Québec–New Hampshire Interconnection

**Hydro-Québec TransÉnergie (HQT) responses to the National Energy Board's Request
for Information **No. 2** dated July 10, 2017**
July 24, 2017

6

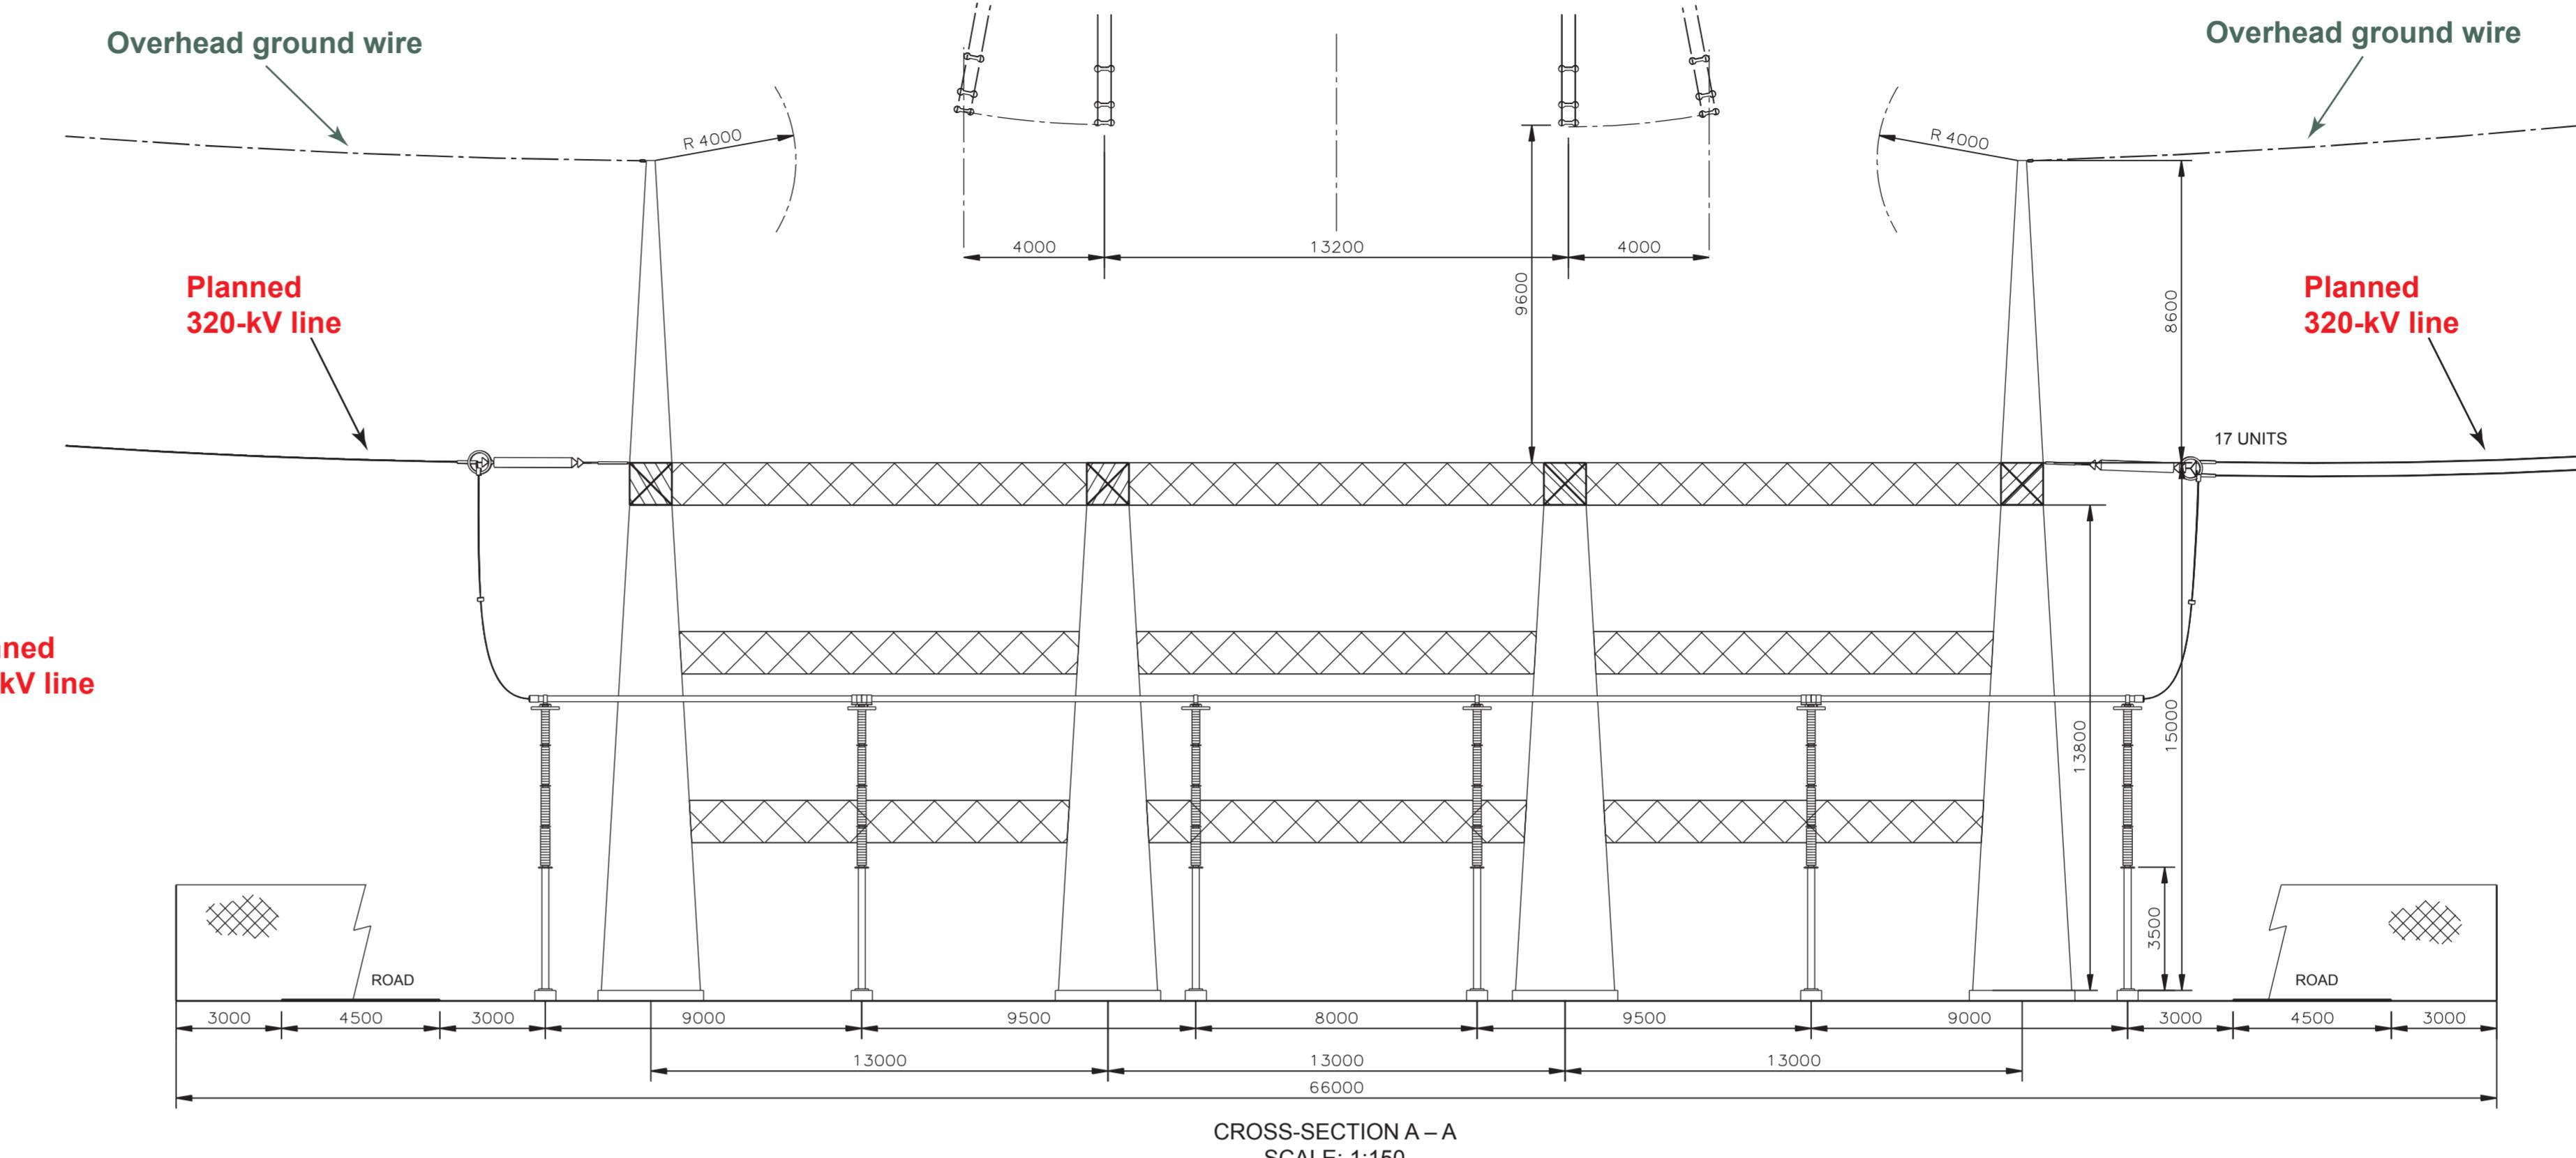
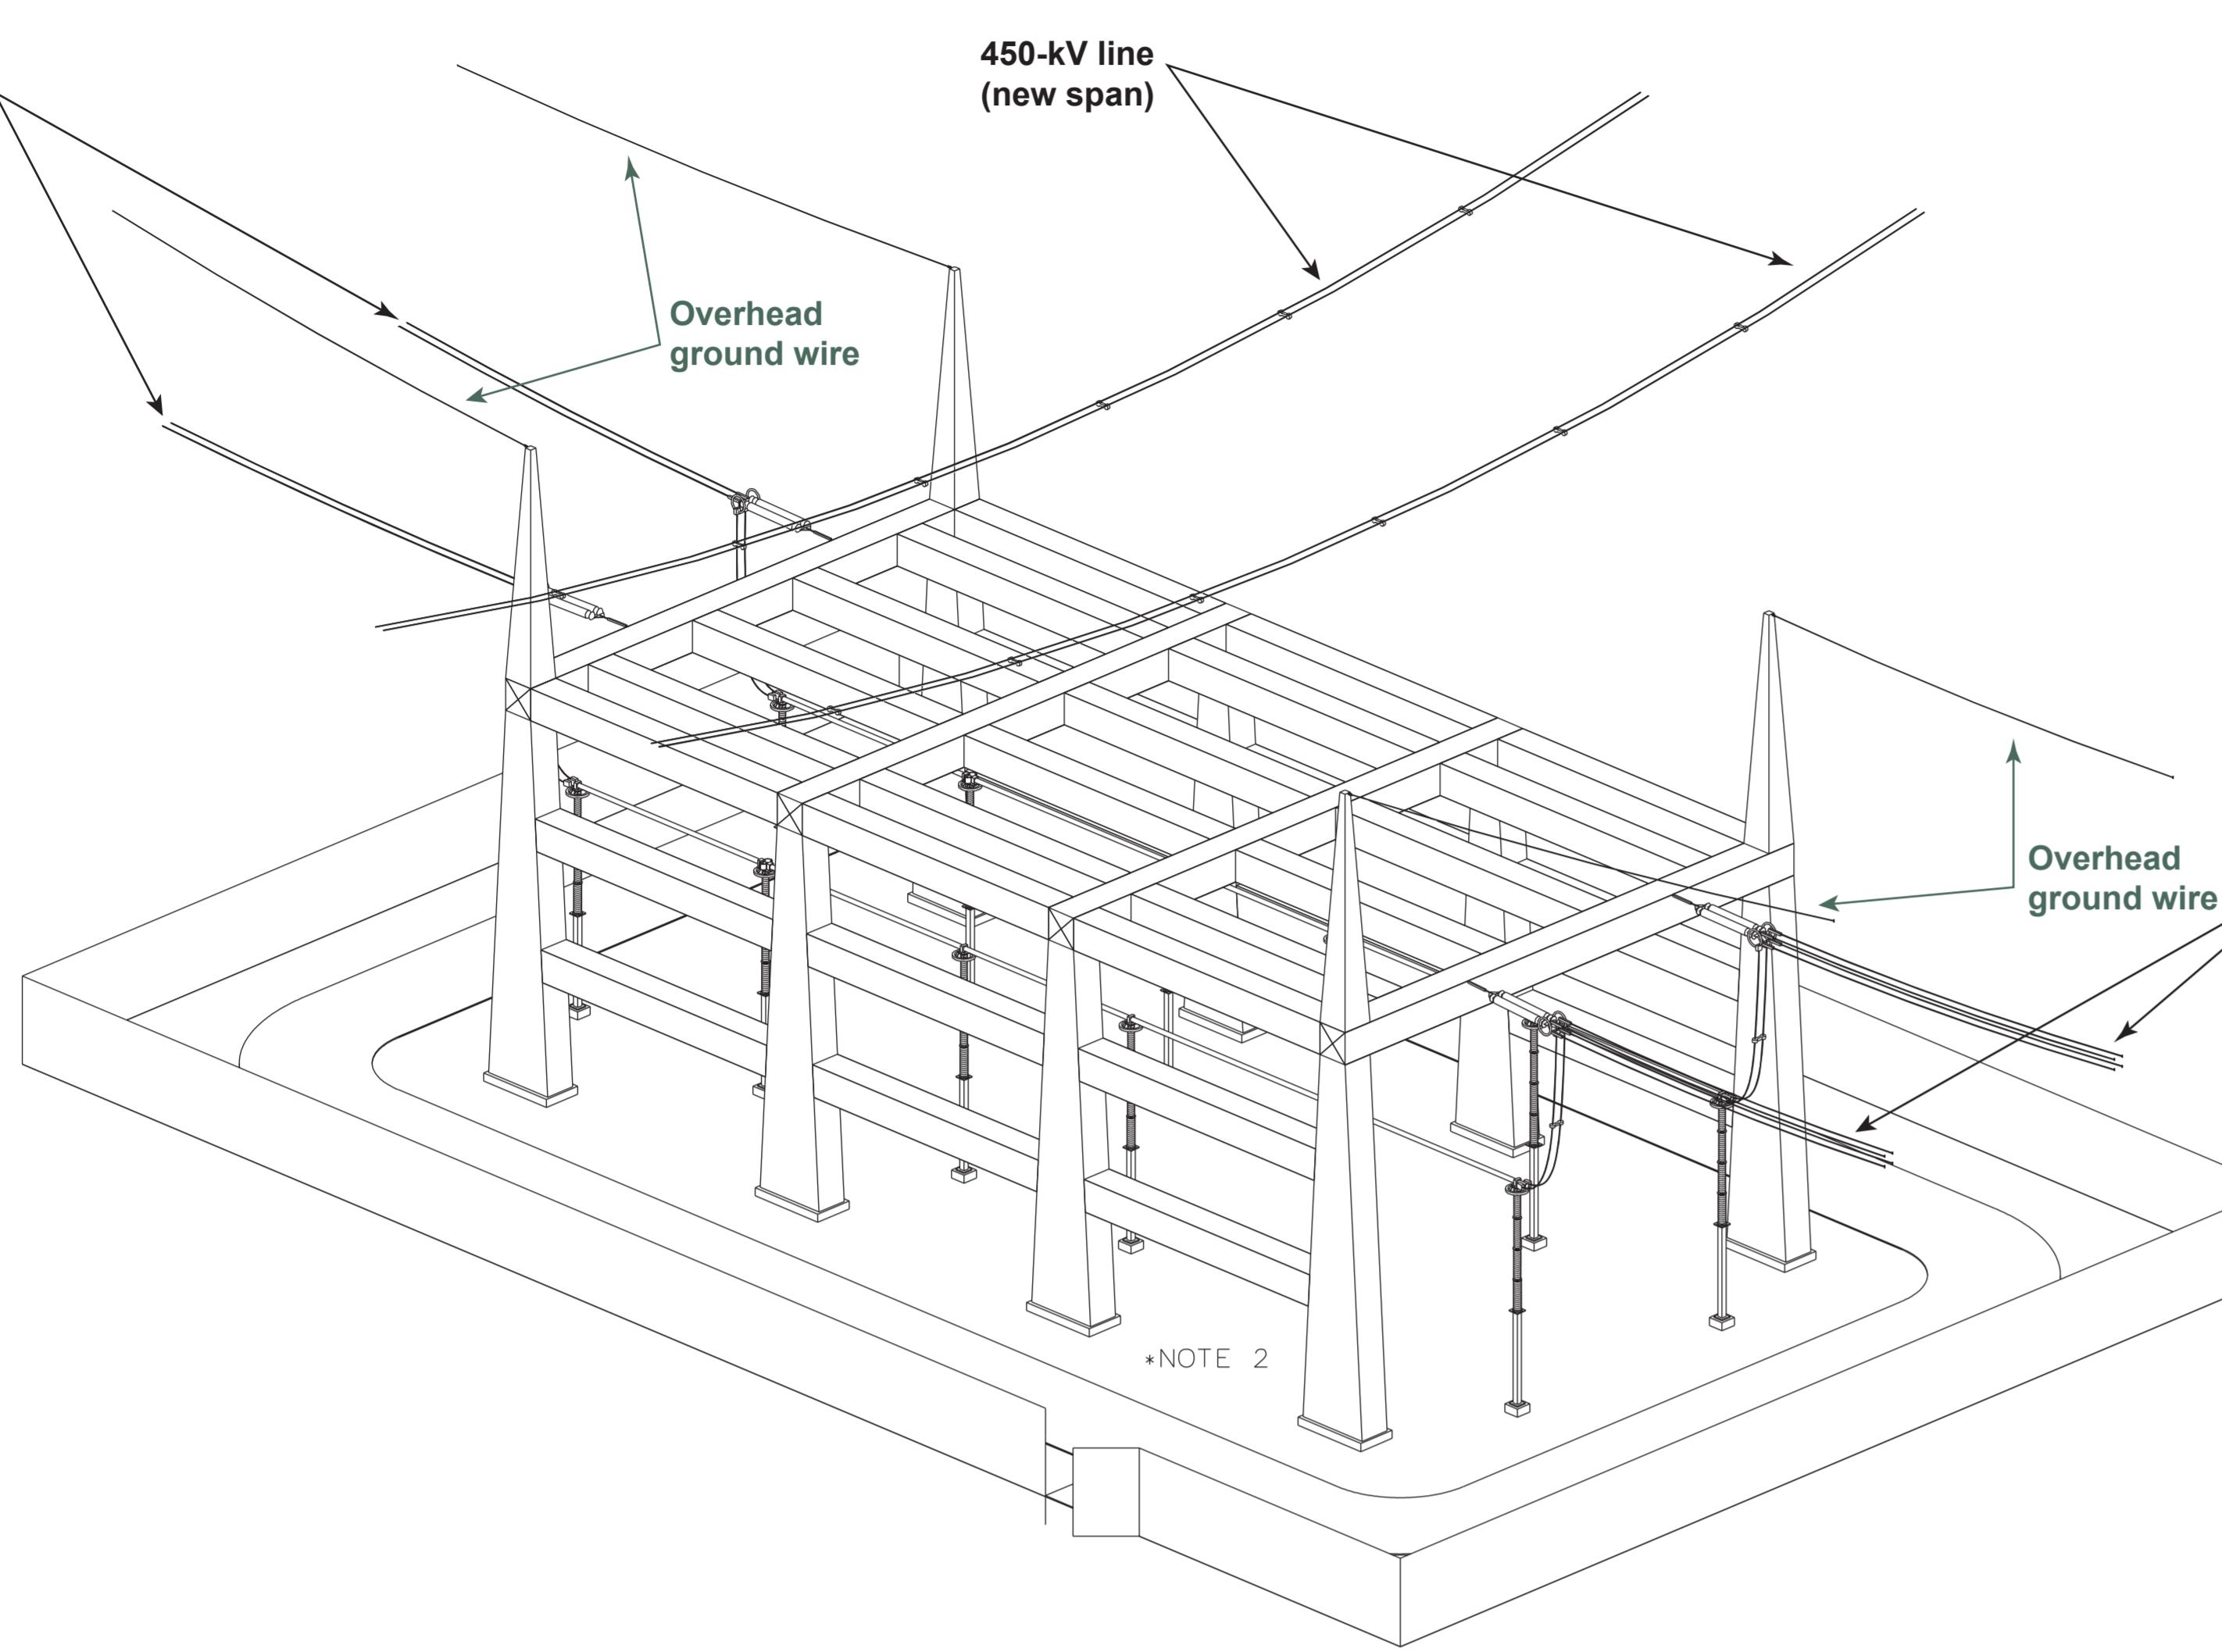
- a) A revised drawing with isometric view showing the following additional components:
 - a.1) The 450 kV line; and
 - a.2) Labels identifying both the 450 kV and 320 kV lines.

Answer 2.3 a) *The drawing provided in Appendix B shows an isometric view and an electrical layout plan of the crossing structure, as well as two cross-sectional views, each of which includes labels clearly identifying the 450-kV and 320-kV lines.*
